Addendum #: Addendum #5
Issue Date: 04/19/2024

The following additions, clarifications and revisions have been made to the Contract Documents:

EDGAR COUNTY, ILLINOIS EDGAR COUNTY PUBLIC SAFETY CENTER

1 ELECTRICAL SITE PLAN
1/16" = 1'-0"

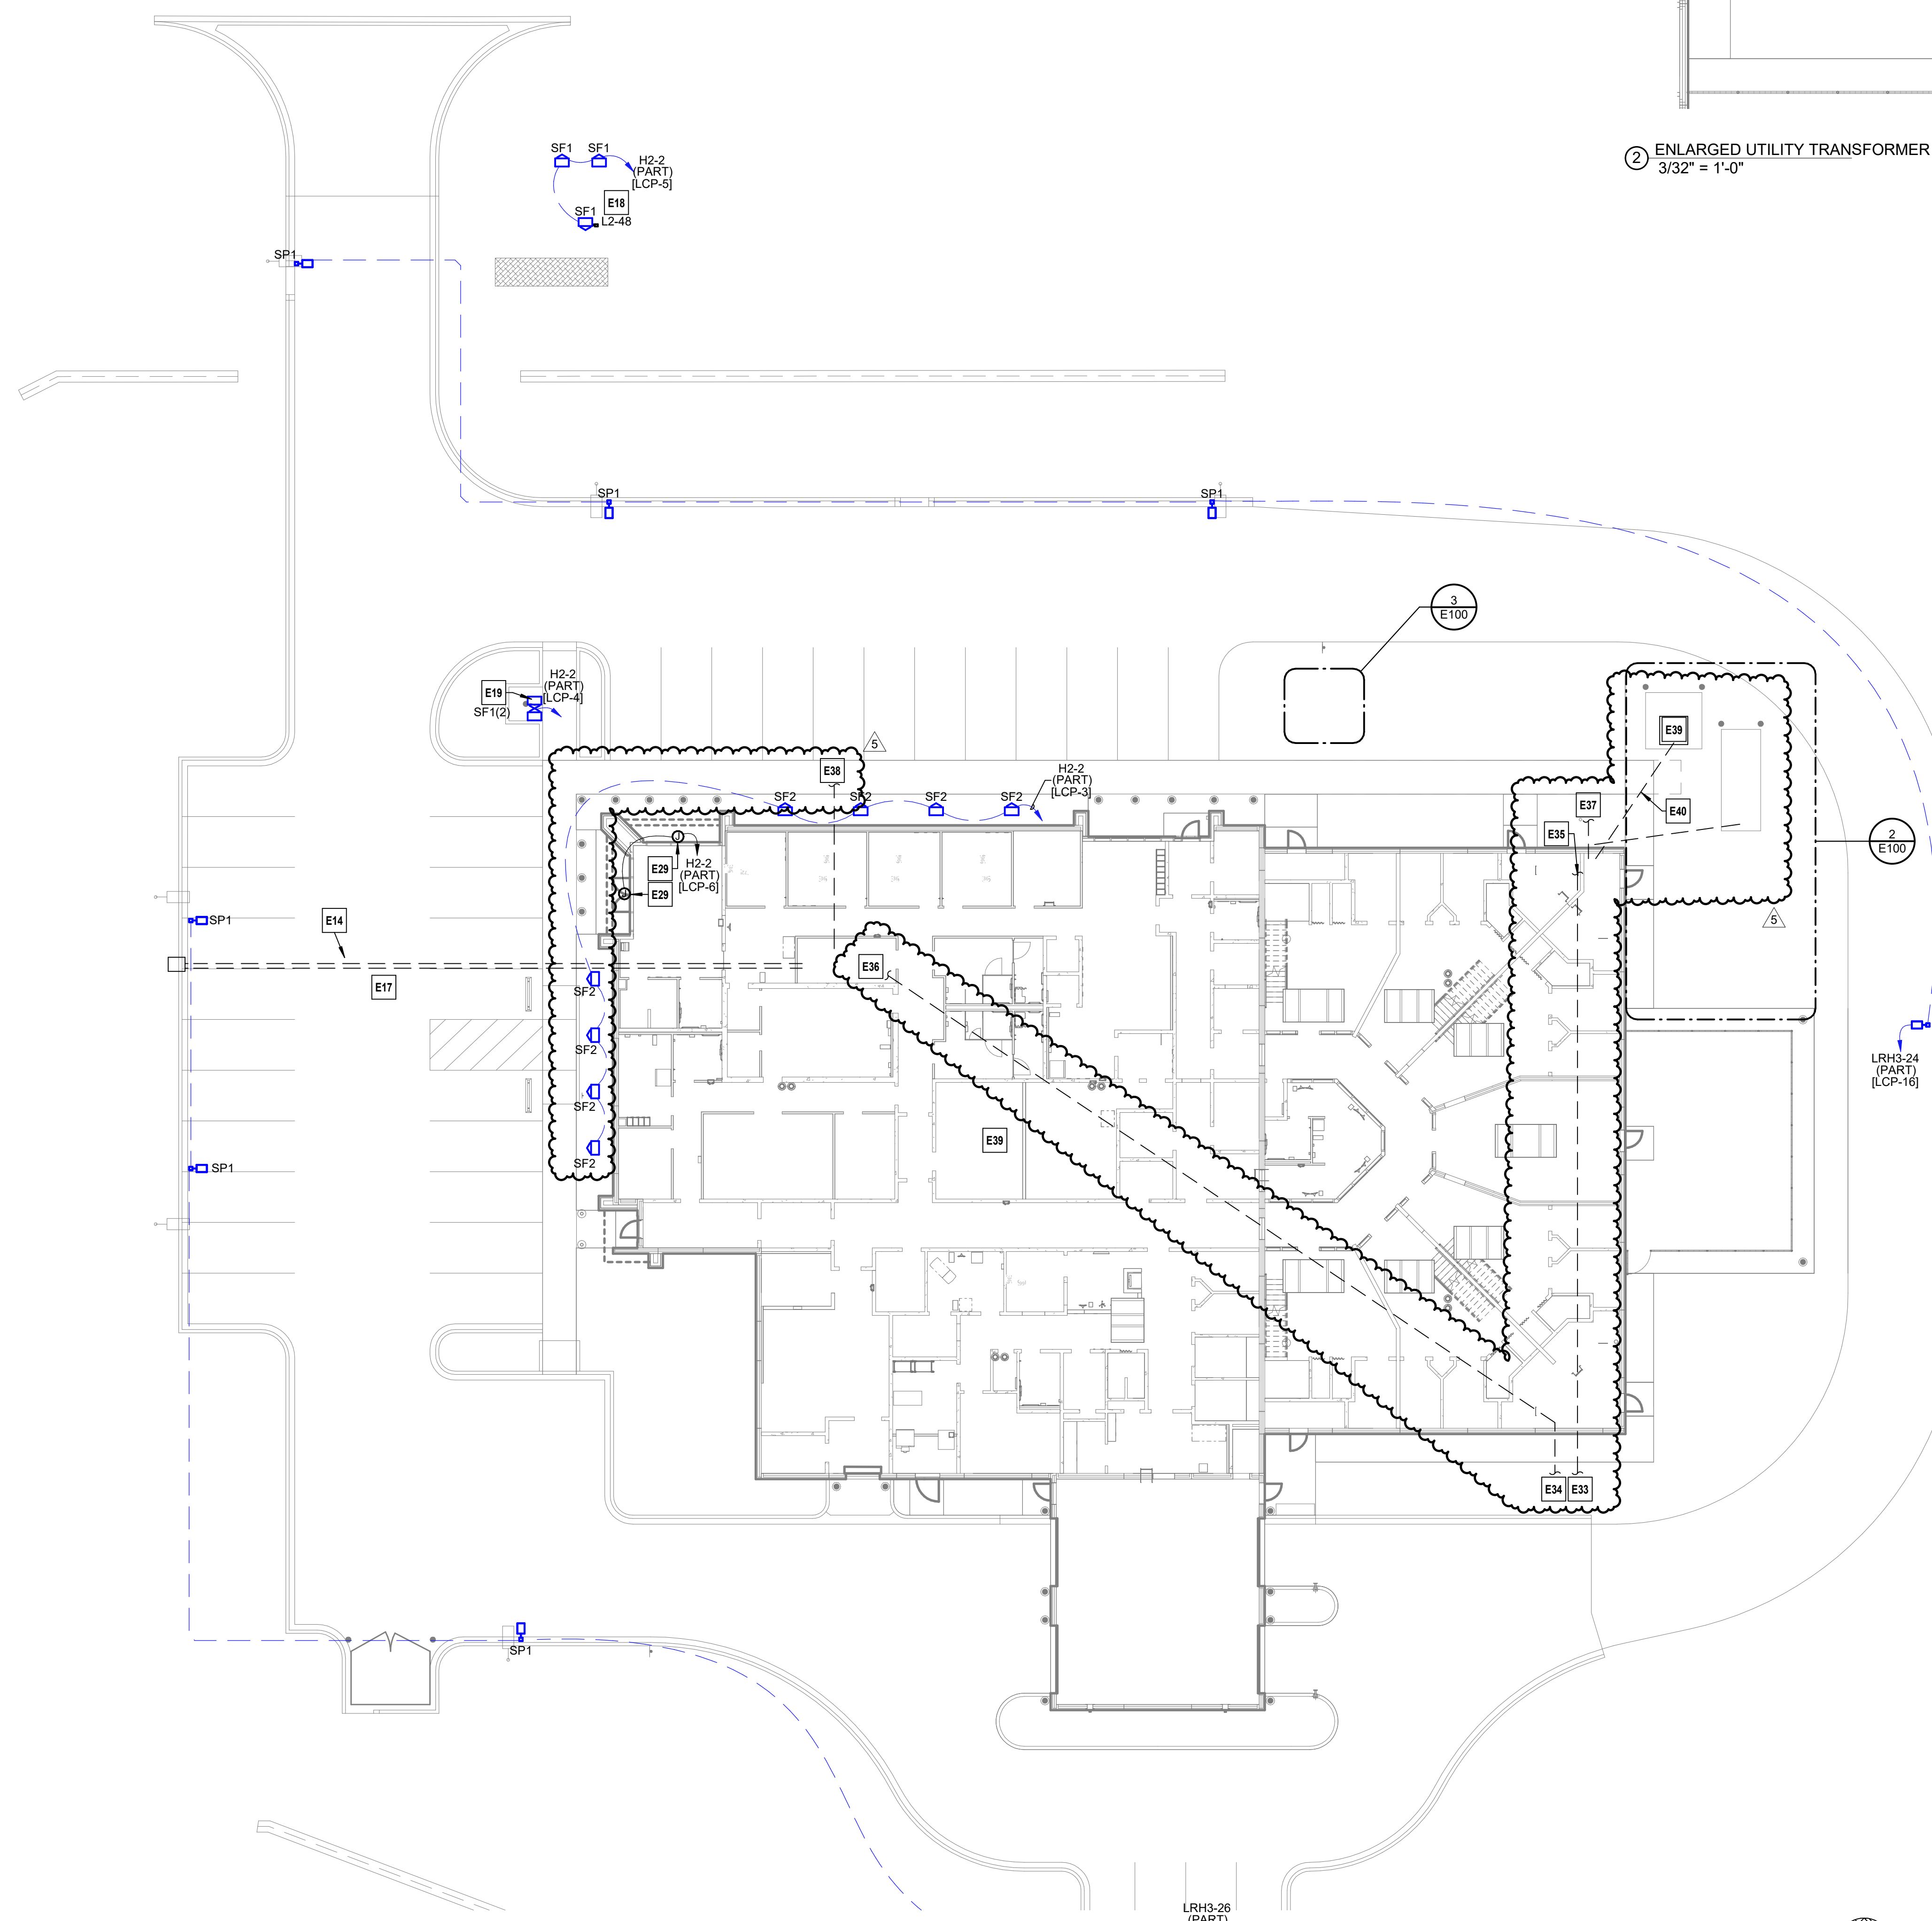
1. SHEET E100 – ELECTRICAL SITE PLAN
 - a. Added keynote and conduits for future metal building and solar panels.
 - b. Added floor up lights on west side of the building.
2. SHEET E301 – EQUIPMENT CONNECTION FIRST FLOOR PLAN - OVERALL
 - a. Added power for door opener for public lobby room 101.
 - b. Added power for door access control.
3. SHEET E302 – EQUIPMENT CONNECTION MEZZANINE PLAN – JAIL
 - a. Added power for rollup door in exercise room.
4. SHEET E500 – ELECTRICAL ONELINE
 - a. Added note for equipment that was part of generator purchase set.
5. SHEET E502 – PANELBOARD SCHEDULE
 - a. Update panelboard schedule.
6. SHEET E503 – PANELBOARD SCHEDULE
 - a. Update panelboard schedule.
7. SHEET E504 – PANELBOARD SCHEDULE
 - a. Update panelboard schedule.

E301

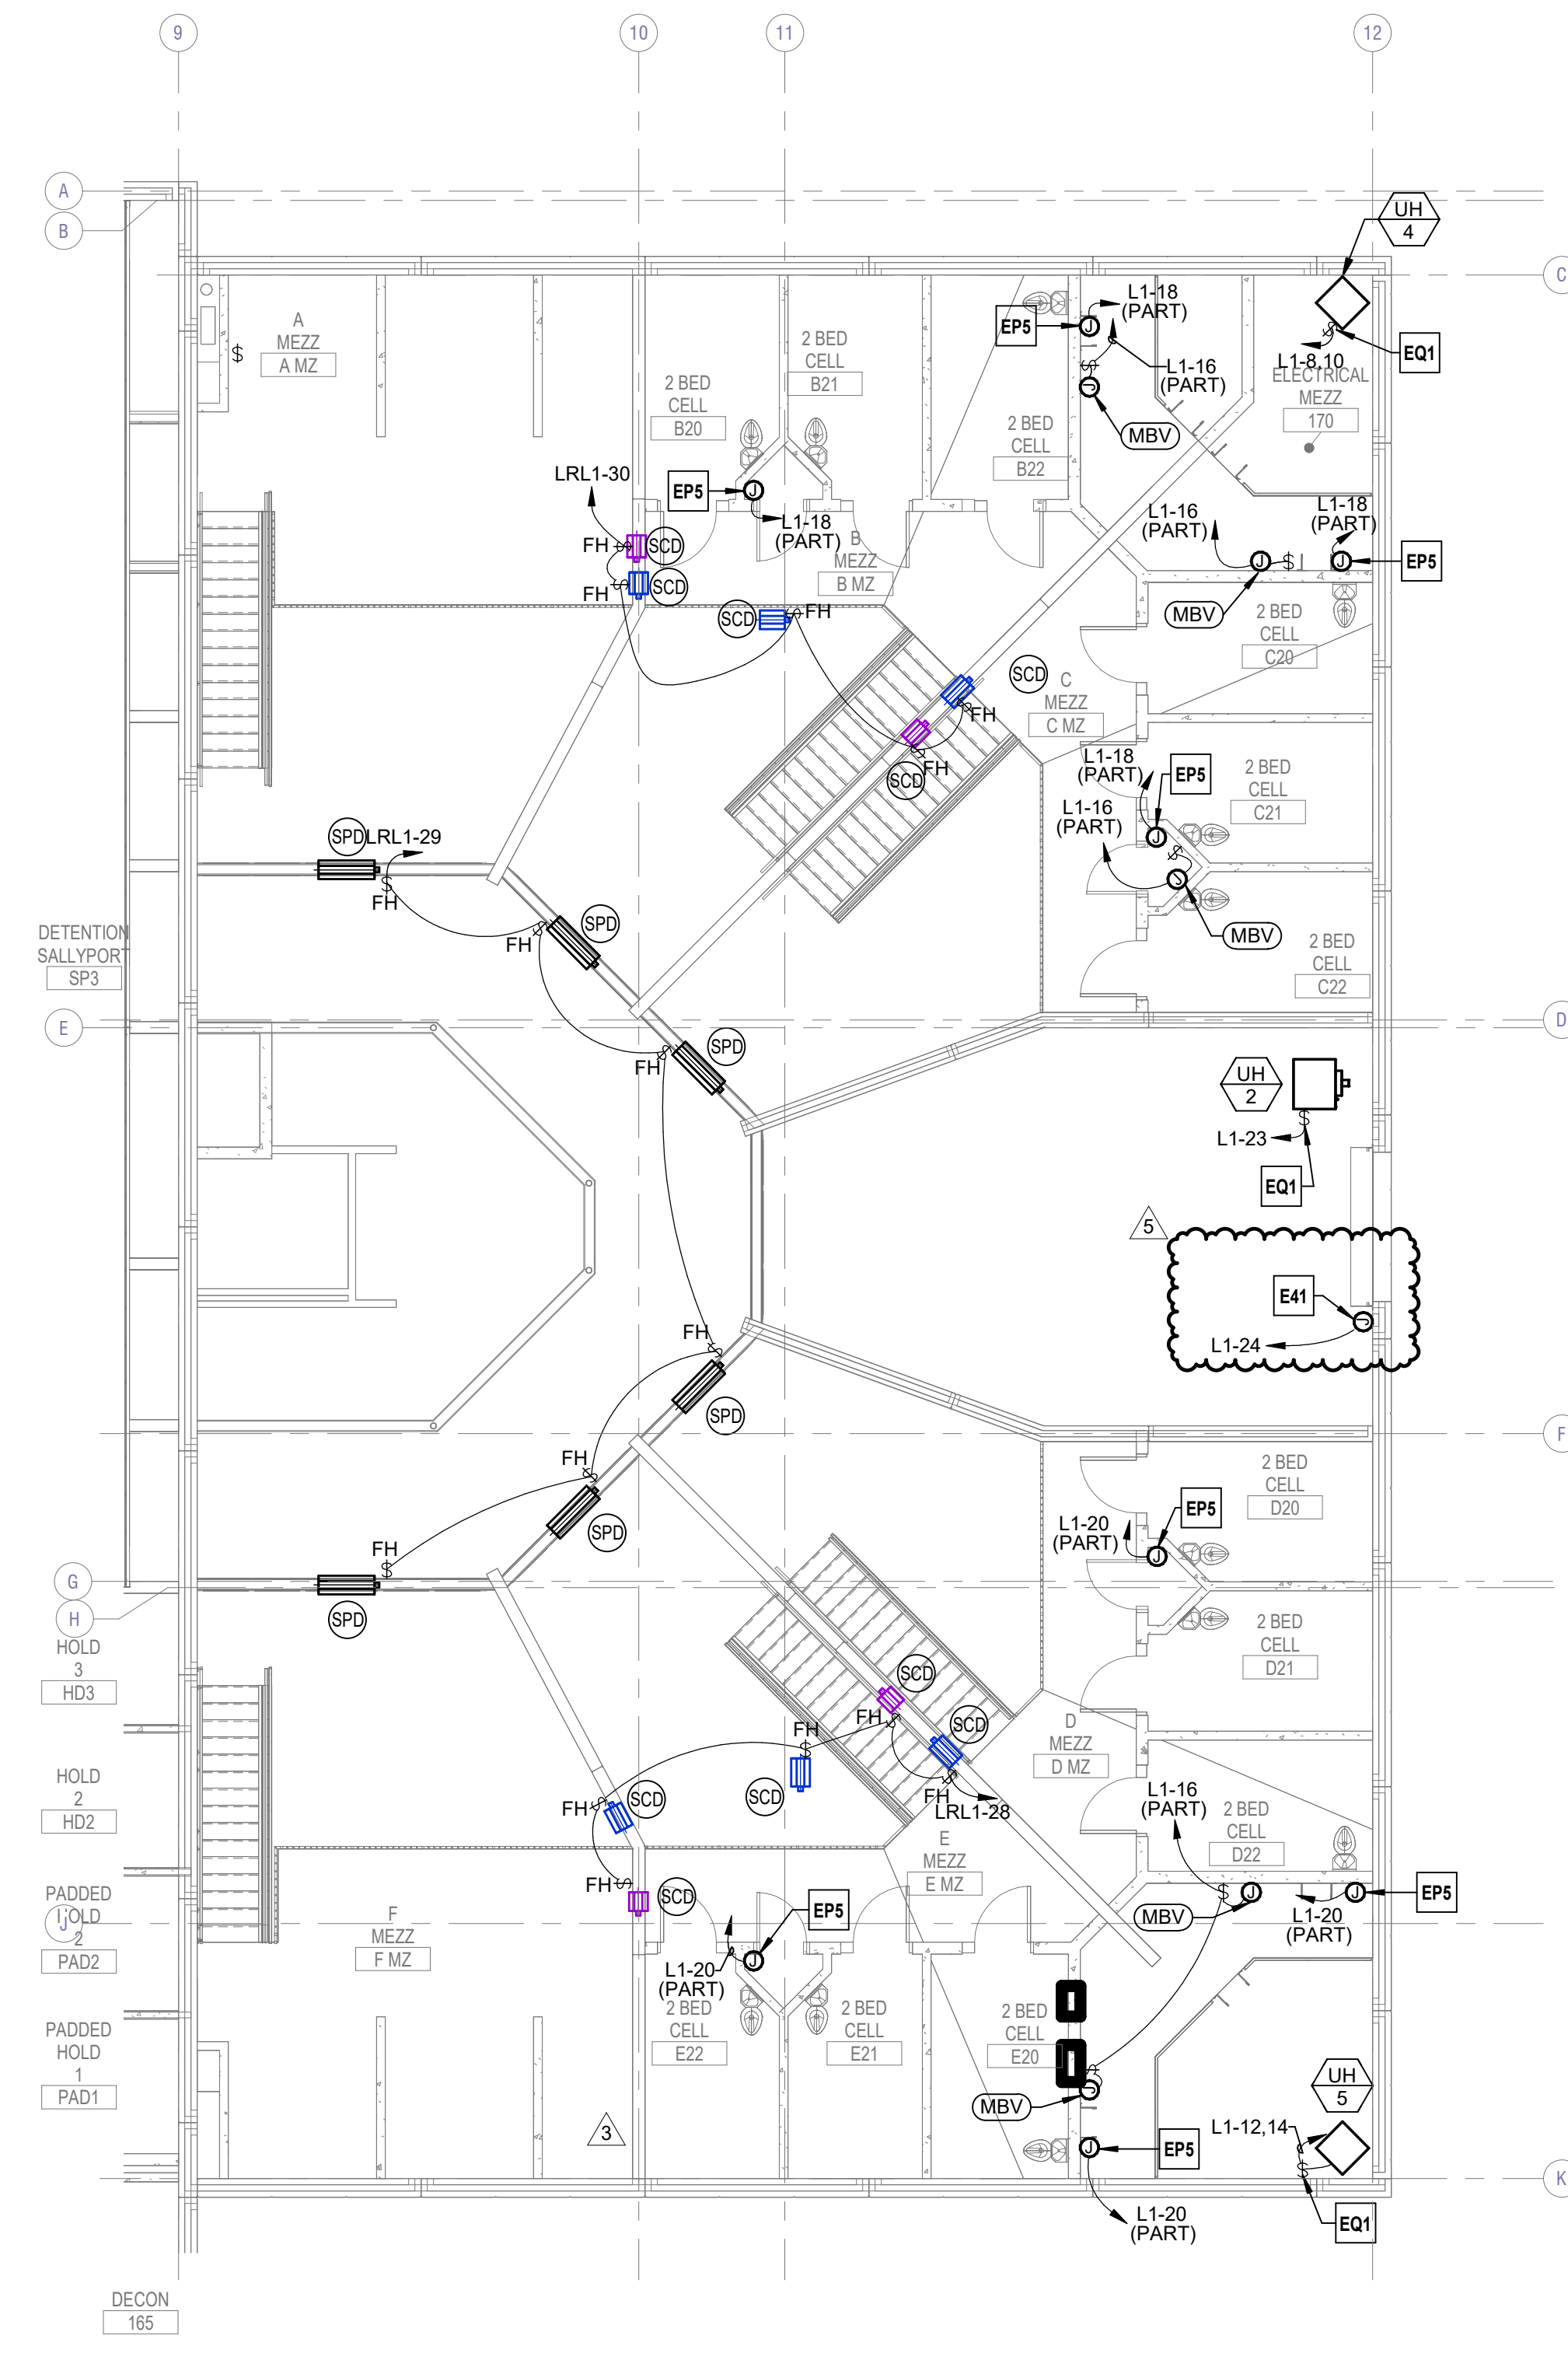
148	Power to mezzanine OH door	Closed		None	Springer, Amanda ...	04/15/2024	Levi Bauer	04/20/2024	04/19/24					
Q:	Levi Bauer Sent Mon Apr 15, 2024 at 04:26 pm CDT E202 doesn't appear to show any power to the overhead coiling door on the mezzanine level. Section 08 3323 indicates this door has an electric operator													
A:	Amanda Springer (Klingner & Associates, P.C) Responded Fri Apr 19, 2024 at 09:13 am CDT REVISE: Added power to door operator. Refer to updated sheet E302.													
147	Door DV1	Closed		None	Springer, Amanda ...	04/15/2024	Levi Bauer	04/20/2024	04/19/24					
Q:	Levi Bauer Sent Mon Apr 15, 2024 at 03:42 pm CDT Door DV1 has hardware set 2 noted in the door hardware schedule which is an access controlled door. E201 does not show any power to this door.													
A:	Amanda Springer (Klingner & Associates, P.C) Responded Fri Apr 19, 2024 at 09:14 am CDT REVISE: Added power for door hardware. Refer to updated sheet E301. ADD 5
